Planning Commission Hearing Date: July 8, 2025
Board of Commissioners Hearing Date: July 24, 2025

STAFF ANALYSIS

CASE NO.:	Z-25-1247529	File ID #: 2025-0628
Address:	3265 Northeast Expressway, Chamblee, GA 30341	Commission District: 01 Super District: 07
Parcel ID(s):	18-267-01-003	
Request:	Rezone property from C-2 (General Commercial) zoning district to HR-1 (High Density Residential-1) zoning district to allow single-family, attached, and multi- family developments.	
Property Owner(s):	Reality Income Corporation	
Applicant/Agent:	LMPSF Acquisitions, LLC c/o Troutman Pepper Locke, LLP	
Acreage:	23 acres	
Existing Land Use:	Formally Regal Cinemas	
Surrounding Properties:	North: OI (Office Institutional) East: OI South: MR-2 (Medium Density Residential - 1), R-100 (Residential Medium Lot-100) West: C-2 (General Commercial).	
Comprehensive Plan:	RC (Regional Center) <u> X </u> Consistent <u> </u> Inconsistent

Site Plan Review (Everstead at Embry Hills, dated 4/25/25):

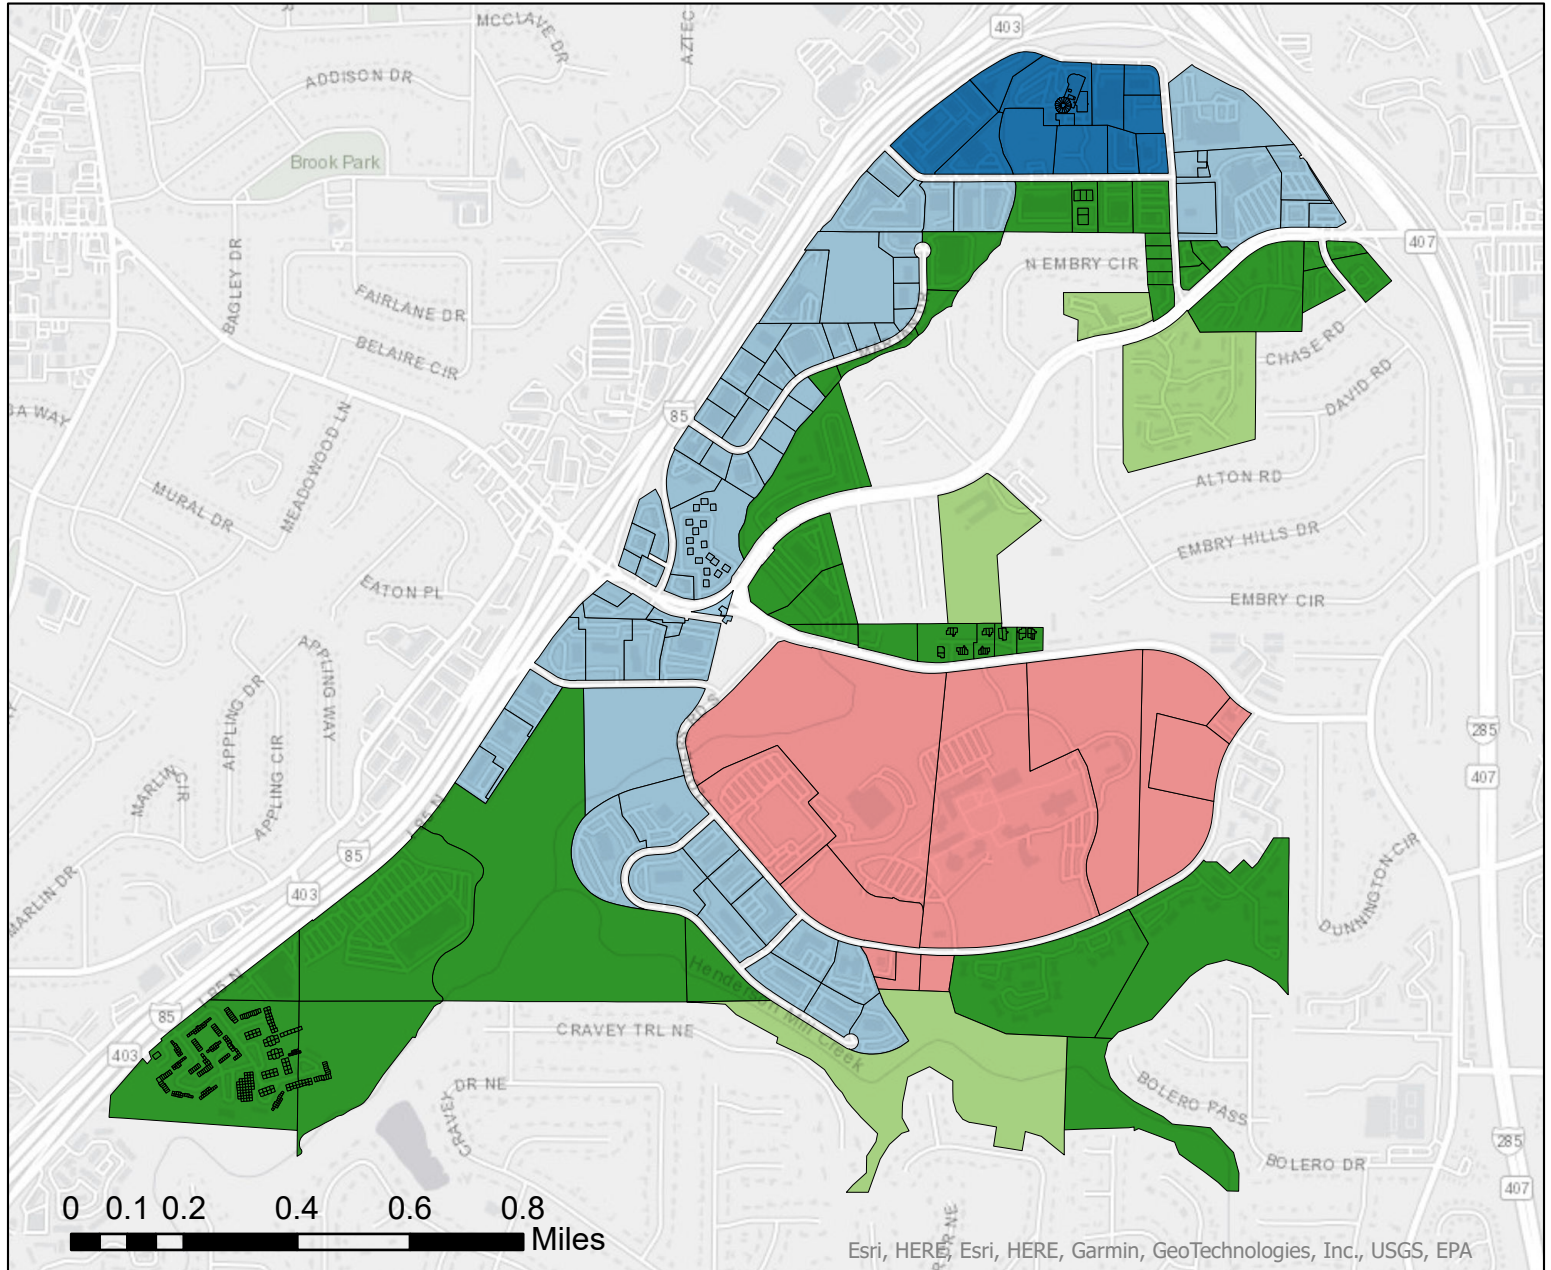
- **Streetscaping** – Applicant did not supply a landscape strip in addition to the ten-foot (10) multiuse path along NE Expressway per *Section 27-5.4.3 – Streetscape Elements and Dimensions (Table 5.1)* and/or what is required by GDOT.

- **Interior strips:** Interior to non-residential, mixed-use and multi-family developments, a three-foot (3) wide planted landscape strips shall be required along all interior drives and pedestrian paths per *Section 5.4.4 - Site and Parking Area Landscaping B*. As well as *D. Parking Area Landscaping tree and island quantity (4 and 5)*.

- **Property perimeter landscape strip:** Along non-residential, mixed-use and multi-family development perimeter lot lines, a perimeter landscape strip shall be required per *Section 5.4.4 C1*. A five-foot-wide continuous perimeter landscape strip is required along all property lines that are not subject to streetscape requirements. This applies to individual tenant sites interior to a master planned project, even in instances where individual tenant sites do not have separately platted lot lines.

- **Unit Size:** The unit size is not listed for the apartment buildings. Per Section, each unit should be a minimum of six hundred and fifty (650) square feet.

- **Entrance Gates:** Multifamily requires gates be located at least fifty (50) feet from the property line to ensure safe queuing, ingress to and egress from the property per *Section 5.4.7 Walls, Fences, and Retaining Walls 8*.

- **Spacing between buildings:** For single-family attached buildings and multi-family buildings, building shall be separated a distance as required by the International Codes Council (IC per *Section 5.2.1 Minimum Required Yards and Buildings Setbacks B1*.

- **Traffic Impact Study:** Multi-family development with over three hundred (300) new units at build-out require a TIS per *Section 5.3.4- Traffic Impact Study A*.

SITE PLAN
EVERSTEAD AT EMBRY HILLS
3265 NORTHEAST EXPRESSWAY, 267 18 CHAMBLEE DEKALB, GEORGIA

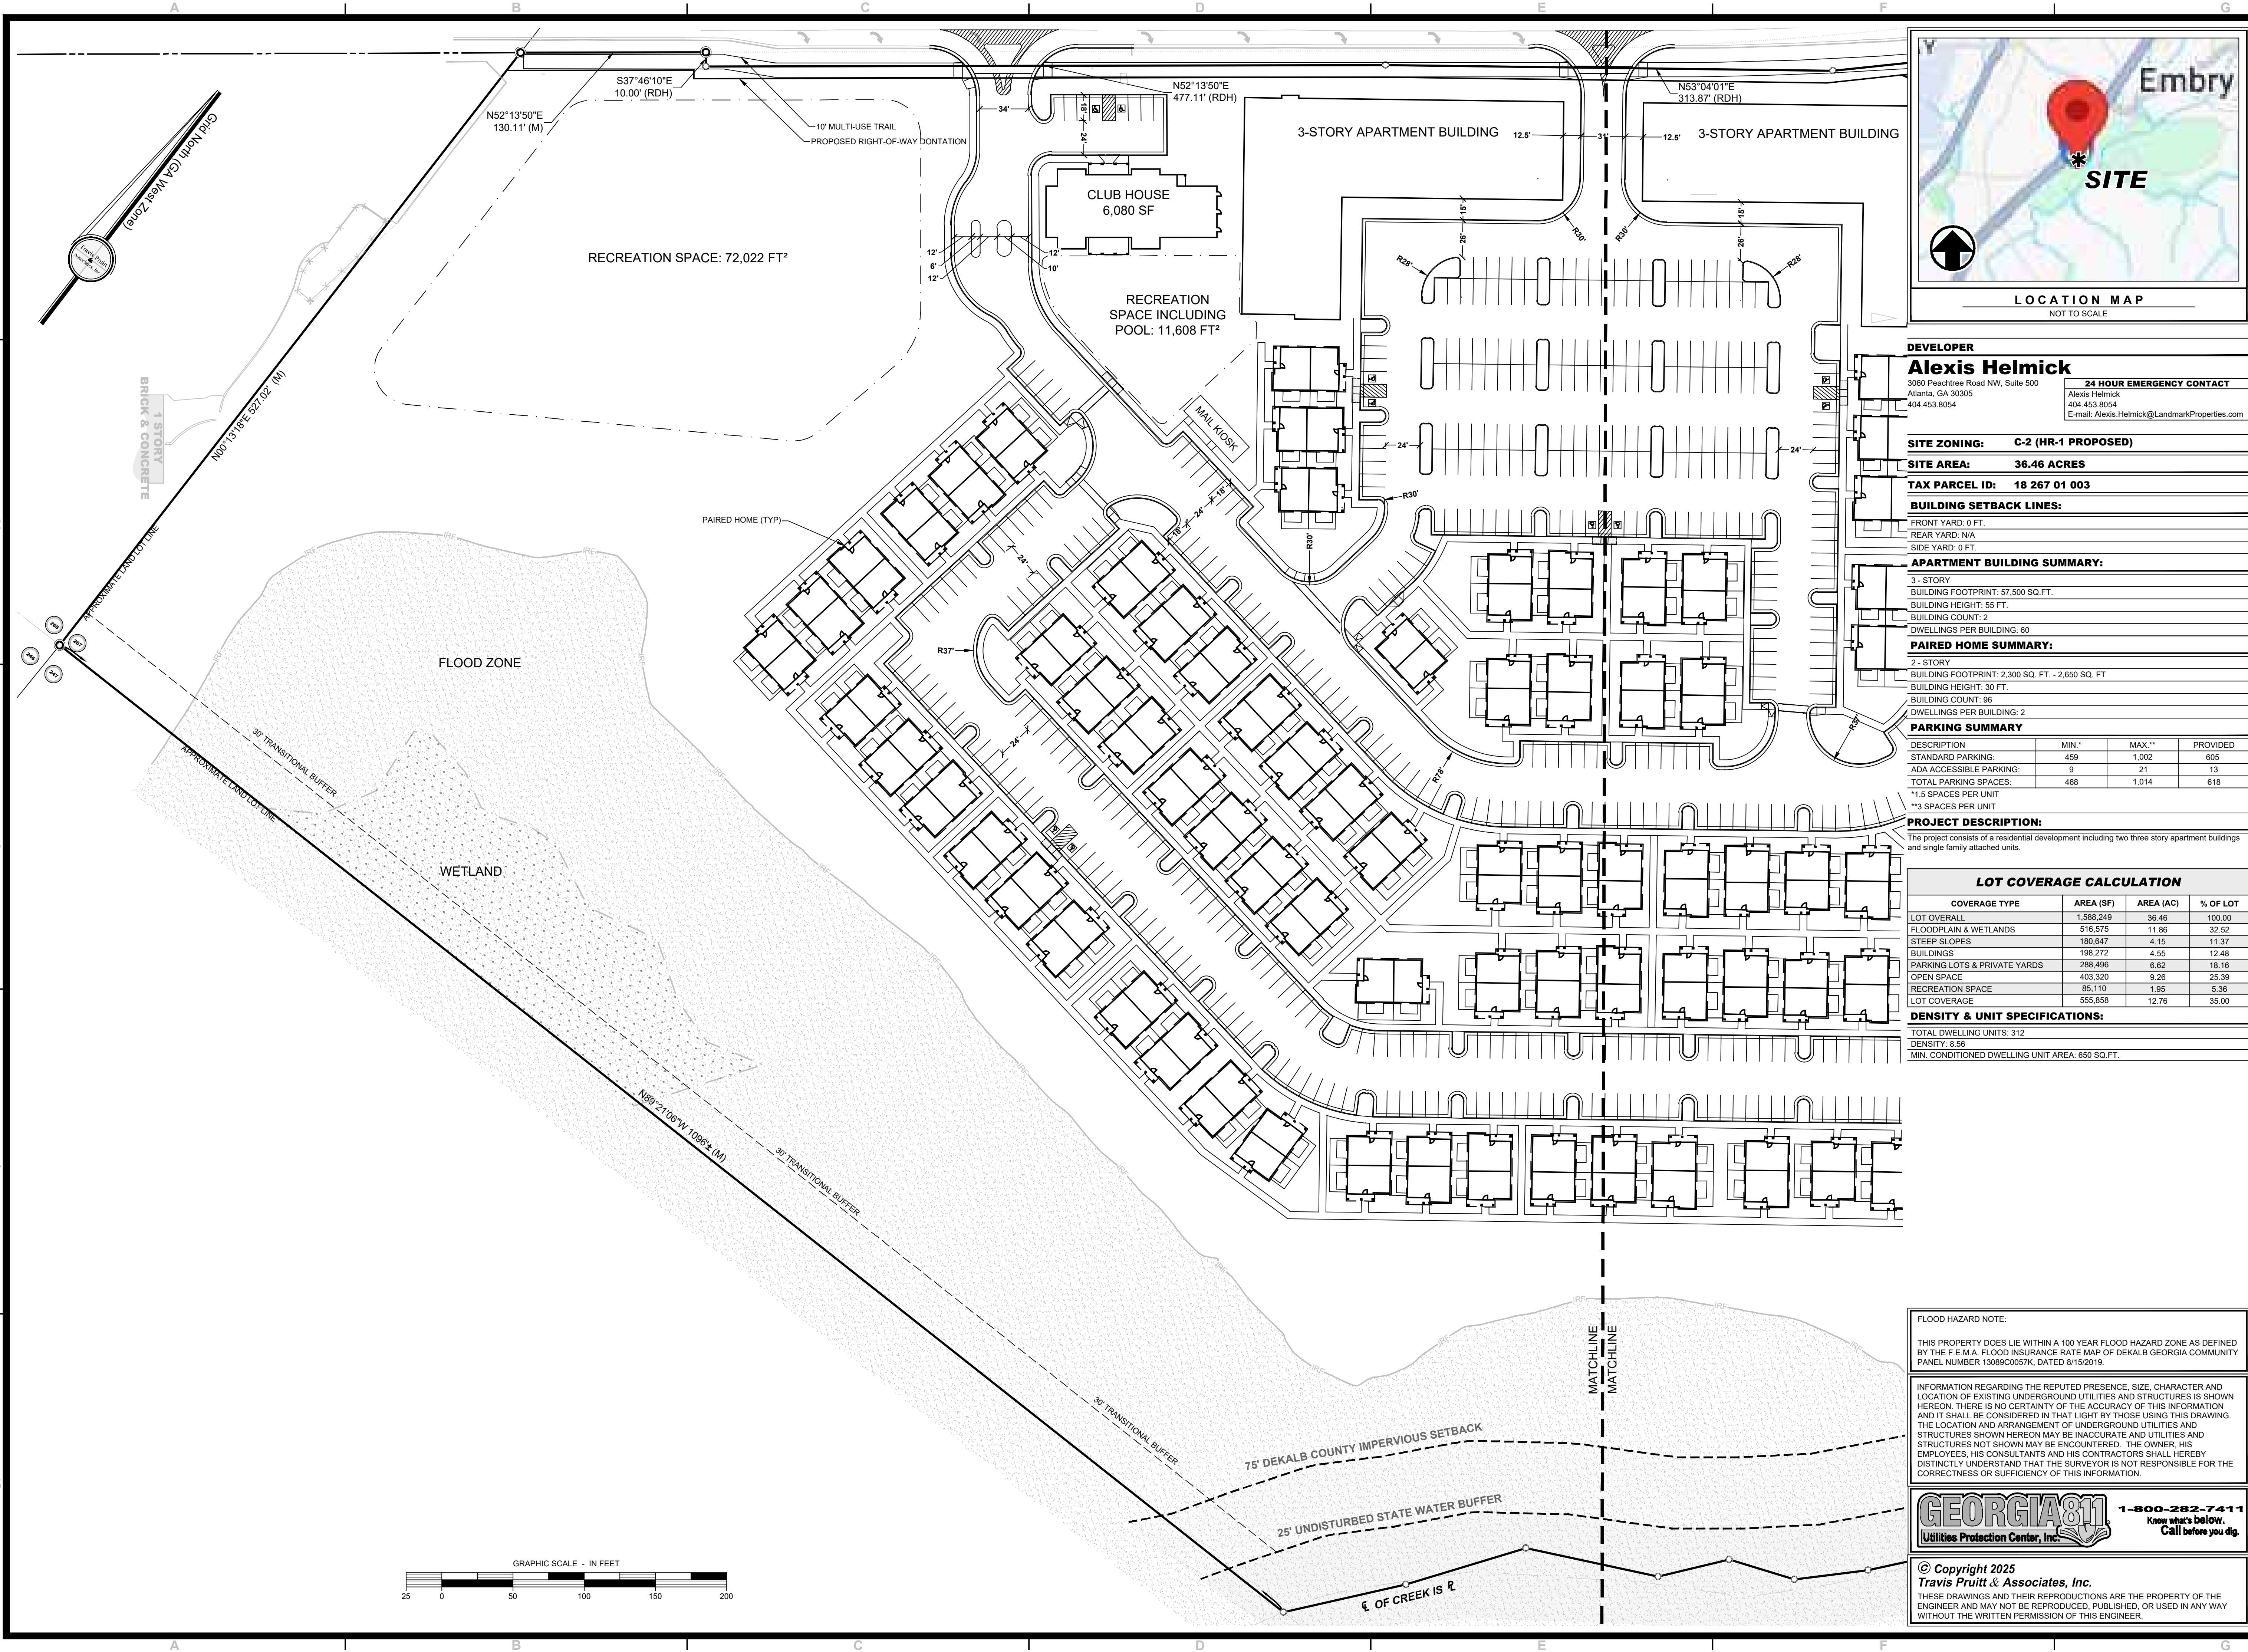
The site plan appears to comply with most of Section 27-2.11.2 – *Dimensional Requirements* for HR-1. However, because of the following deficiencies, variances may need to be sought.
